# Product Change Notification (PCN)

| PCN Number                              | 511302   | Date Issued | December 14, 2021 |
| Reason for Change                       | Change to Product  |             |                   |

## Before Change

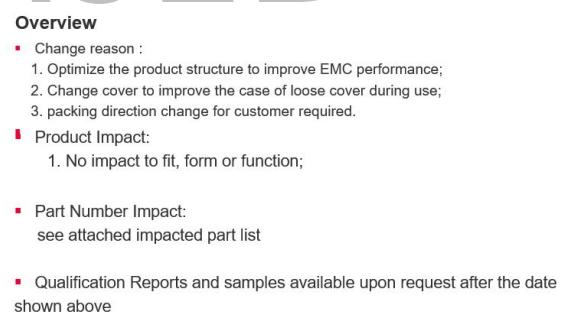
- Change reason :
  - 1. Optimize the product structure to improve EMC performance;
  - 2. Change cover to improve the case of loose cover during use;
  - 3. packing direction change for customer required.
- Product Impact:
  - 1. No impact to fit, form or function;
  - 2. Part Number Impact: see attached impacted part list
  - 3. Qualification Reports and samples available upon request after the date shown above
